Planning Commission Staff Report

Subject: Treasure
Project #: PL-08-00370
Authors: Francisco Astorga, AICP, Senior Planner
Date: 25 October 2017
Type of Item: Administrative – Conditional Use Permit Refinement 17.2 Update

During the [October 11, 2017](#) Planning Commission meeting, the Commission requested that the Planning Department to provide an analysis of Refinement 17.2 and the Plans provided on the Sweeney Properties Master Plan (SPMP) produced by Eugene Woodruff. Staff prepared the following exhibits to allow the Planning Commission to compare the original SPMP approval plans/documents (Master Plan/Woodruff) and Refinement 17.2:

SHEET NO.
29

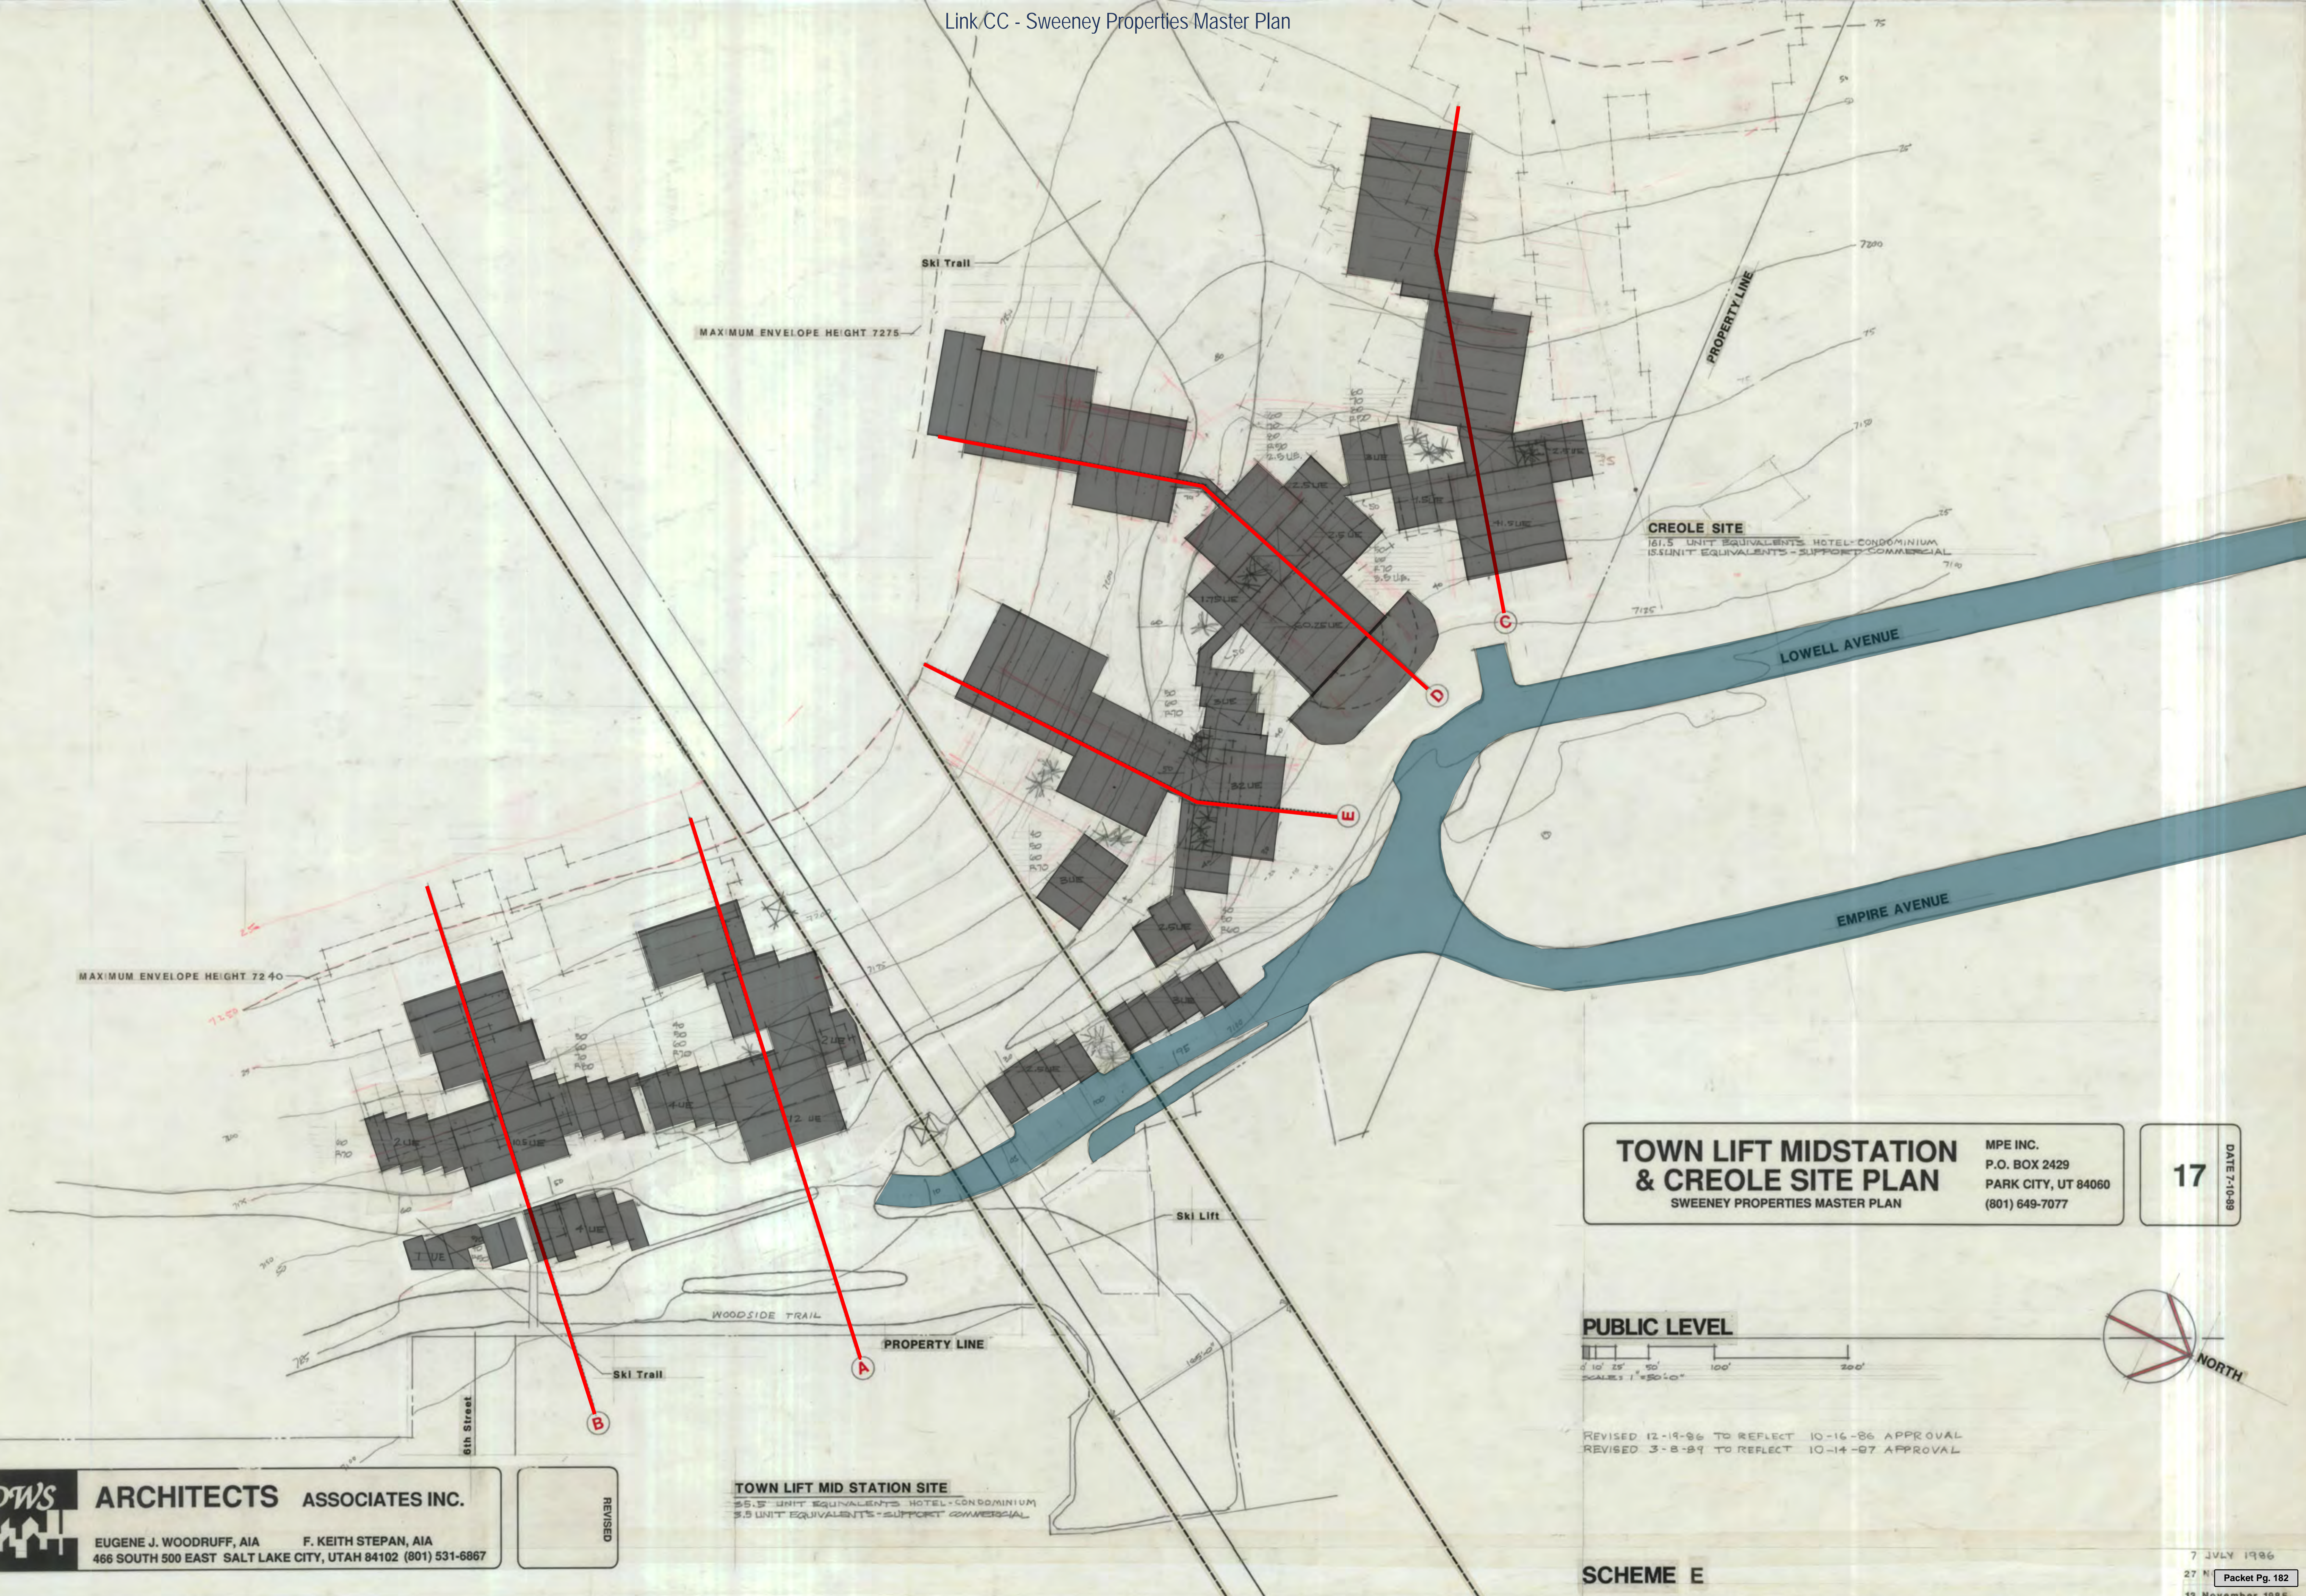
27. Sample elevation C and E show compliance with the building sections/height zone plan, measured from existing grade. Sample elevation D was not updated/amended to show the adopted height as the change is indeed reflected on the building section sheet 17 and height zone plan sheet 22.
28. Sheet 28 and 29 show each ski run bi-furcating its corresponding site as well as the development boundaries.

ELEVATION BUILDING A

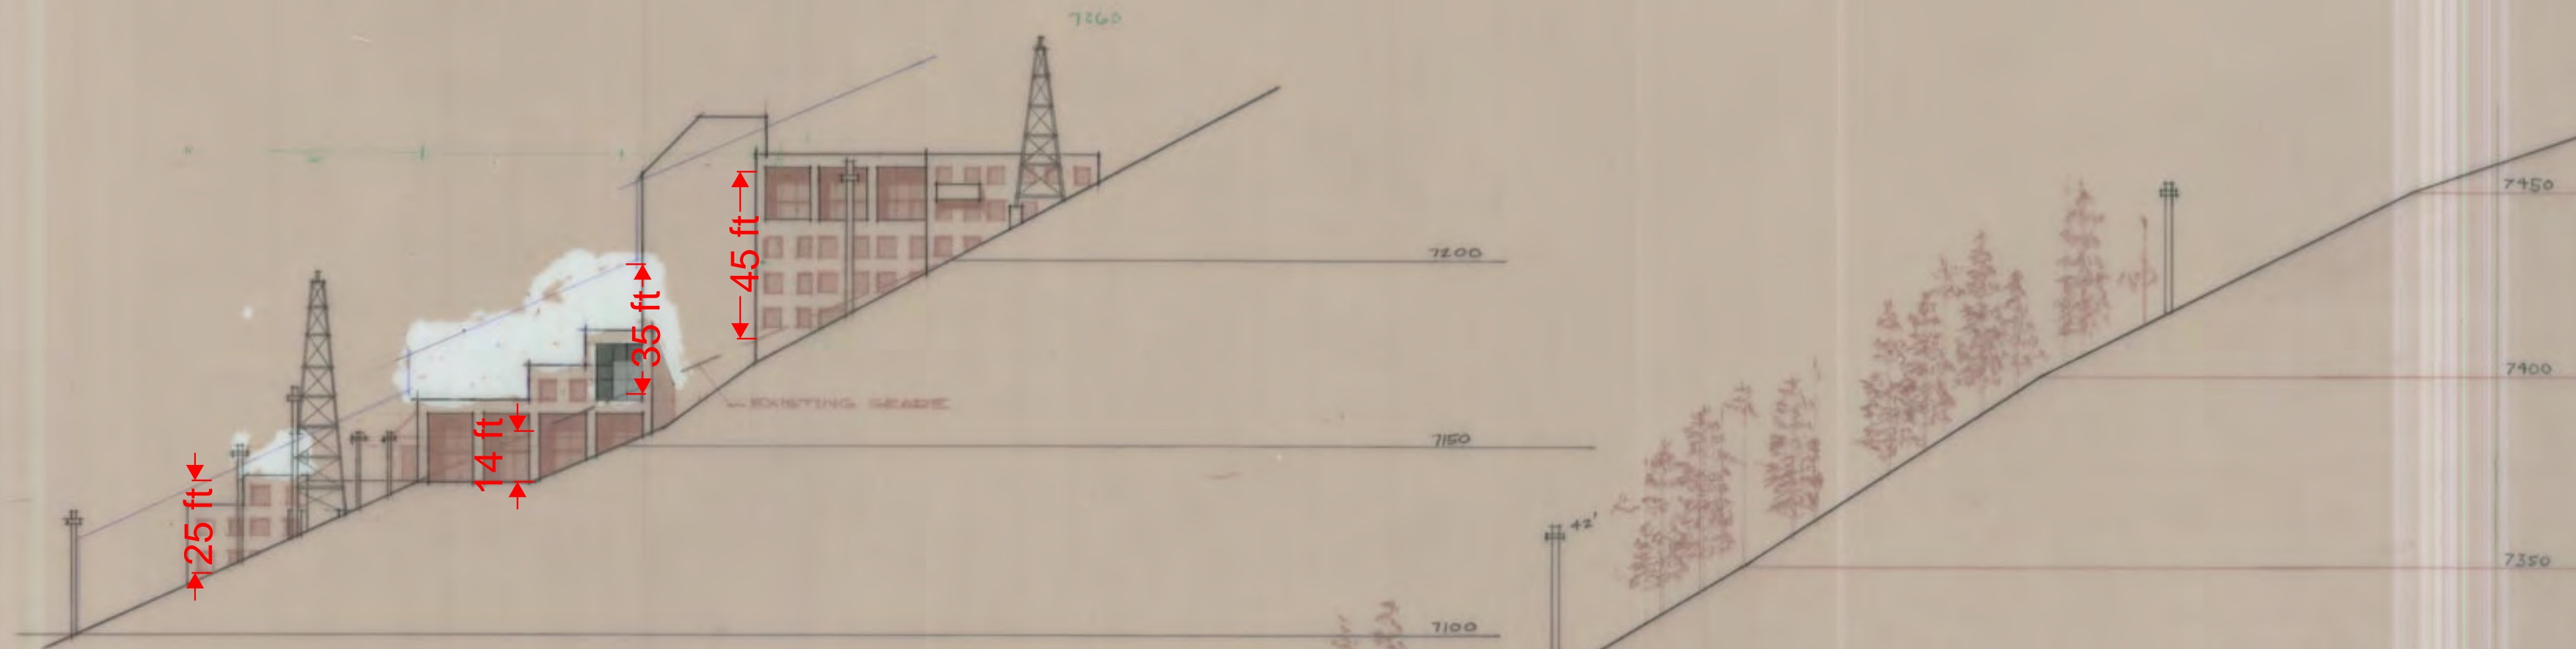
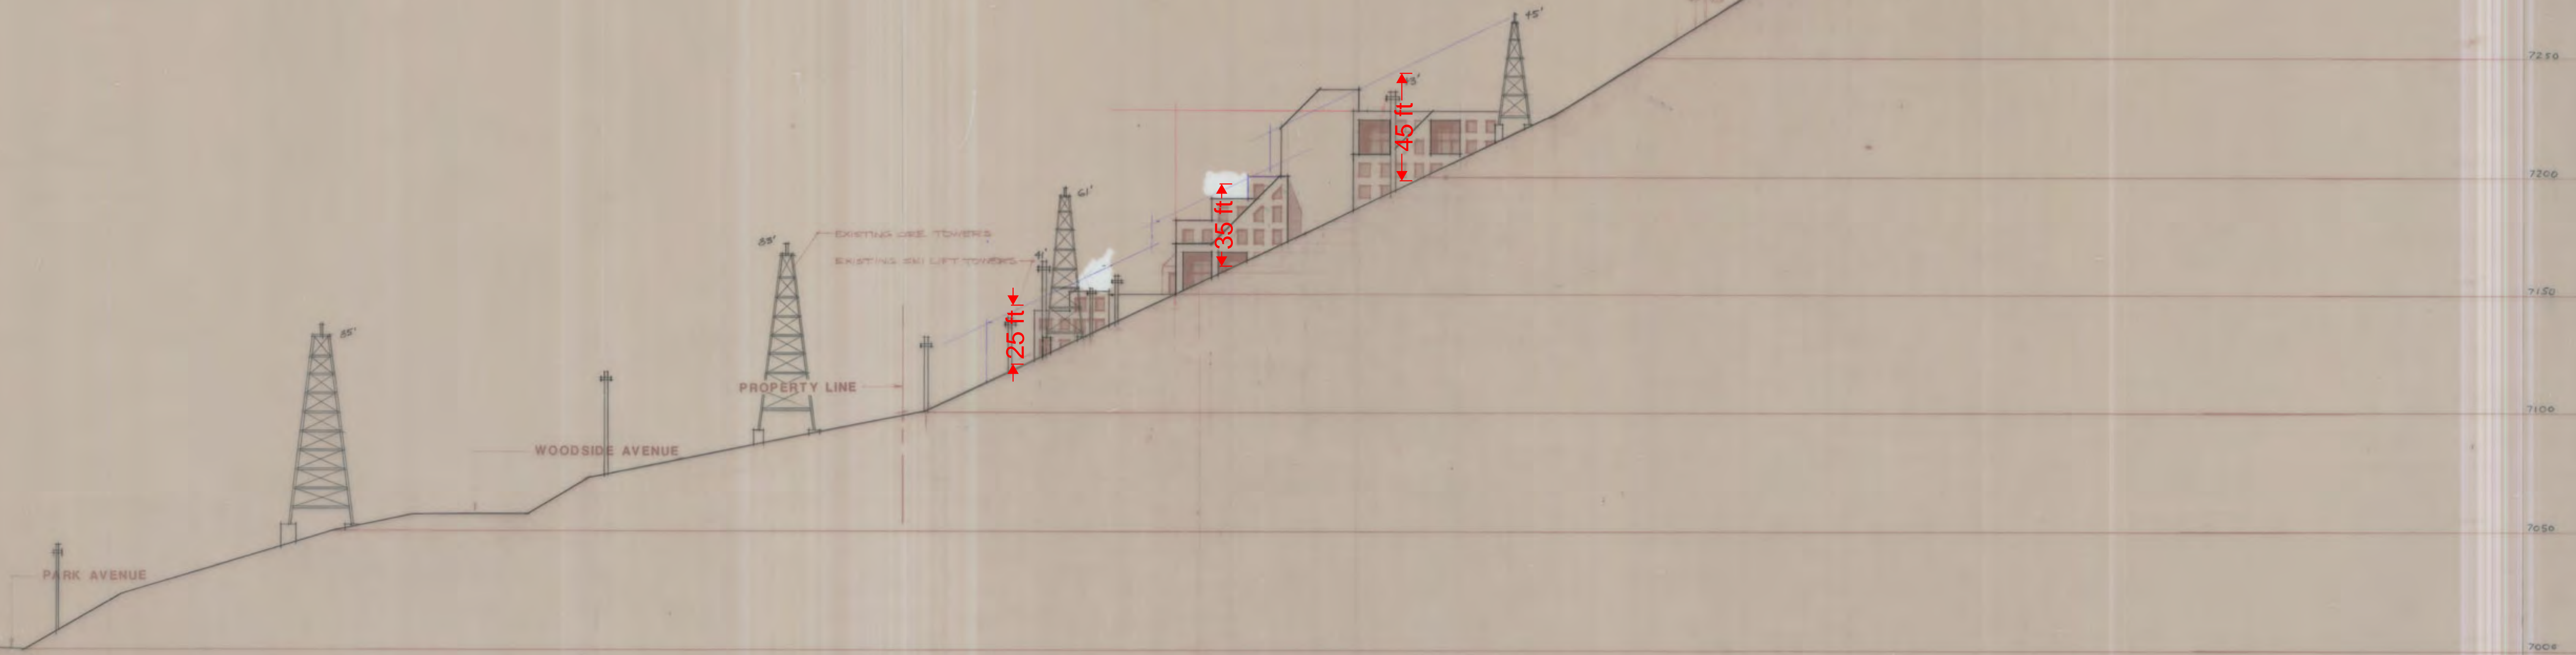
16. Sheet 23 and 24 are sample elevations for both sites.
17. The Mid-Station sample elevations sheet 23, comply with the building sections/height zone plan, measured from existing grade.

18. Sample elevations building A and B are in the Mid-Station site.
19. Sample elevation A shows excavation/re-grading existing grade at the periphery of the structure to final grade about half-way through the building at approximately 14 feet.

20. Sample elevation B does not show any re-grading along the periphery of the building elevation.
21. Sample elevations building C, D, and E are in the Creole-Gulch site.
